Memo

To: Tim Clinkscales, PE Paramounte Engineering
From: Nicole Smith, Associate Planner; 910-341-1611
CC: File;
Date: 6/22/2020
Re: Crossroads Infiniti

■ CROSSROADS INFINITI [TRC Plan Review #5]

Departure Sight Triangles (Stop-Controlled)

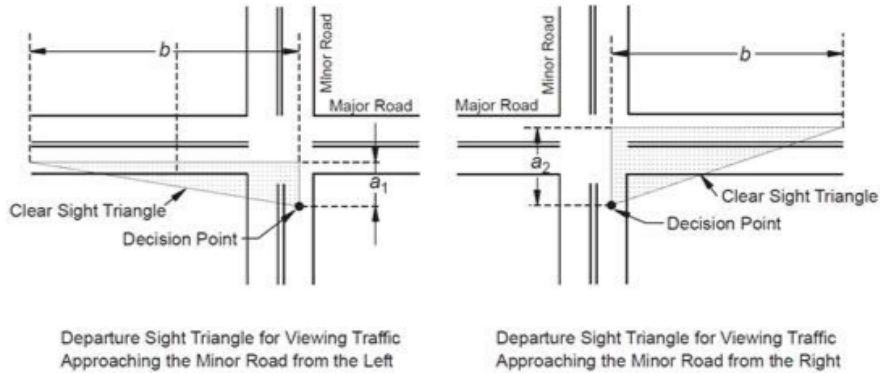
- **SIGHT DISTANCE TRIANGLE FOR ANY STREET/DRIVEWAY INTERSECTIONS WITH THOROUGHFARES**

Market St is a major thoroughfare [Chap VII (C) (2) (a) of CofW Tech Stds]. In accordance with the City Code, sight distances along thoroughfares must be calculated in compliance with the AASHTO requirements. [Chap VII (C) (1) of CofW Tech Stds] [Sec.18-556 CofW LDC]. Show AASHTO in addition to 20'x70' SDT for the driveway off Market St.

Chapter 9, Section 9.5.3 Case B. Provide the dimensions and lines for a_1 , a_2 , b based on the design speed on Market St.
